Service Technical Information

| MODEL NO. XR-MDS7 / MS3 |
| SUBJECT Noise During CD Playback |

REF.No. :G - A0 - 016 - E0

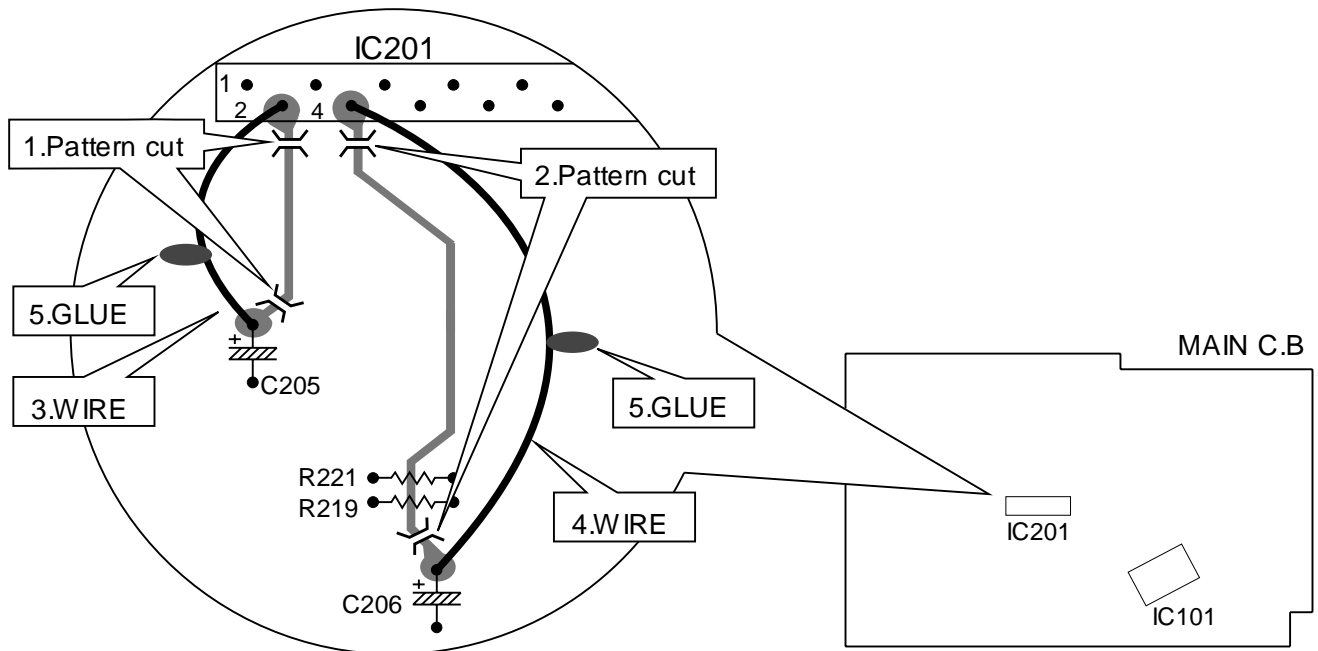
There are times when complaint is made that "Noise comes from the speaker during CD playback. This is particularly noticeable at low volumes."

- 1) Cut the pattern (at two locations) between Pin 2 of IC201 and the + terminal of C205.
- 2) Cut the pattern (at two locations) between Pin 4 of IC201 and the + terminal pin of C206.
- 3) Connect Pin 2 of IC201 and the + terminal pin of C205 using a jumper wire.
- 4) Connect Pin 4 of IC201 and the + terminal pin of C206 using a jumper wire.
- 5) Fix the connected jumper wires using a spot of glue (1600Y).

Since it is possible that the symptom may not get improved depending on the position of the wires, Adjust the position of the wires and fix them at the best position.
